Product Change Notice of Arena Sport Series LED Drivers

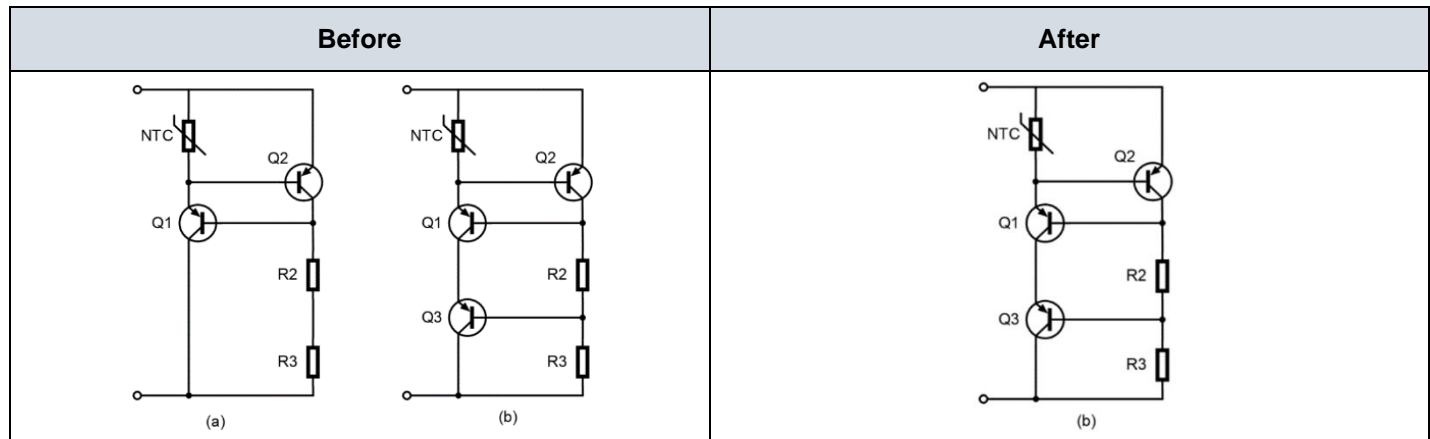
Delta Electronics, Inc. ("Delta") would like to notify you about the necessary modification/change on the requirement on NTC detection circuit of the LED module for the Arena Sport series. We just delete the NTC circuit (a) and keep NTC circuit (b) only, but all the parameters of the components in the circuit remain unchanged (see the table). This new requirement is aimed at ensuring the consistency of temperature sampling accuracy and the anti-interference capability.
